**COMMITTEE OF ADJUSTMENT REPORT
MINOR VARIANCE APPLICATION
A037/22
17 Winterlude Ct Kleinburg
ADJOURNMENT REQUIRED**

ITEM NUMBER: 6.4	CITY WARD #: 1
APPLICANT:	Luigi & Loredana Guarascio
AGENT:	Andre Grisolia
PROPERTY:	17 Winterlude Ct Kleinburg
ZONING DESIGNATION:	See Below
VAUGHAN OFFICIAL PLAN (2010) DESIGNATION:	Vaughan Official Plan 2010 ('VOP 2010'): "Low-Rise Residential"
RELATED DEVELOPMENT APPLICATIONS:	None
PURPOSE OF APPLICATION:	Relief from the Zoning By-law is being requested to permit the construction of a proposed loggia, cabana and retaining wall to be located in the rear yard.

TITLE: PROPOSED CABANA POOL AND POOL HOUSE/POOL EQUIPMENT ROOM AT 17 WINTERLUDE COURT IN THE CITY OF VAUGHAN
 CLIENT: MR AND MRS GUARASCIO
 DATE: JUNE 2022
 DRAWN BY: A. GRISOLIA
 SCALE: 1/8" = 1'-0"

DRAWING NUMBER: SP-1

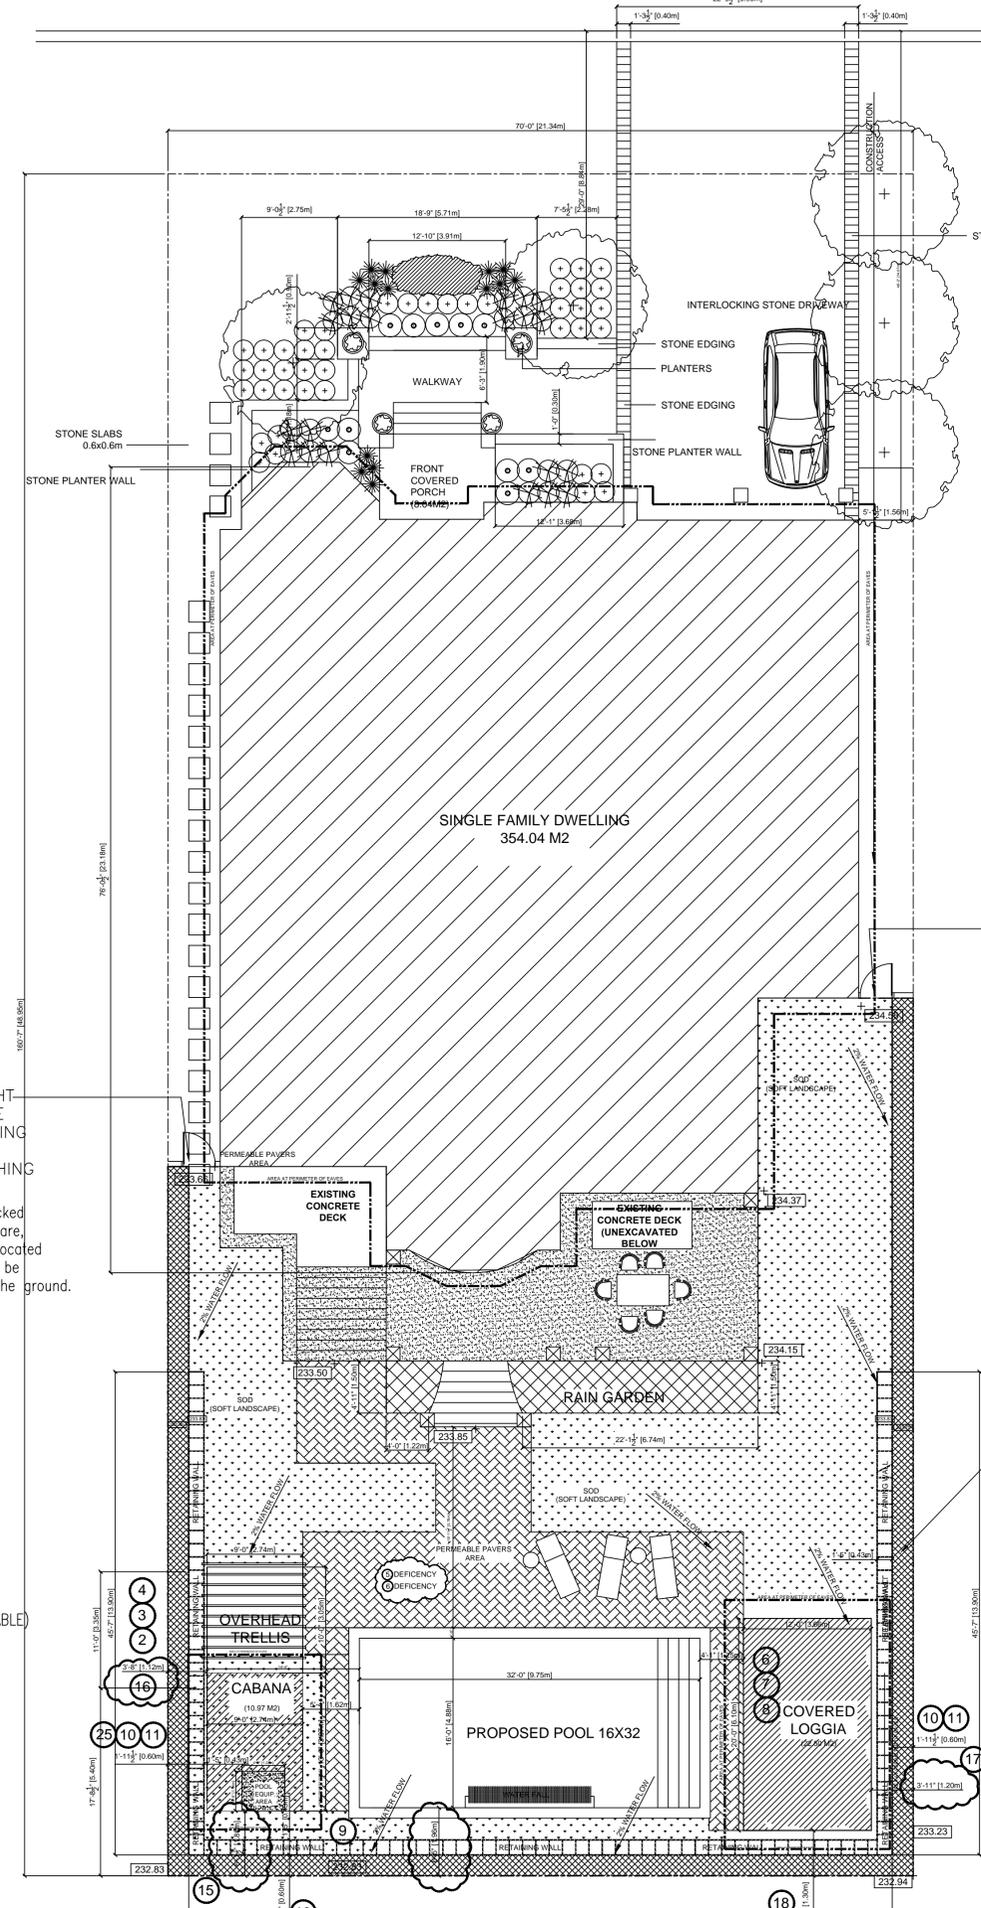
Proposed Loggia shows some type of fireplace under the Flat Screen TV There is not note to the type of fuel. Electric, natural Gas, or propane. No solid fuel burning unit and chimney to be permitted.	
Fire Department Recommended Conditions of Approval:	None

General Comments	
1	The applicant shall be advised that additional variances may be required upon review of detailed drawing for building permit/site plan approval.
2	The information provided for grading/height is not consistent throughout all drawings submitted. The figure(s) that resulted in the largest height were used for the purposes of this review.
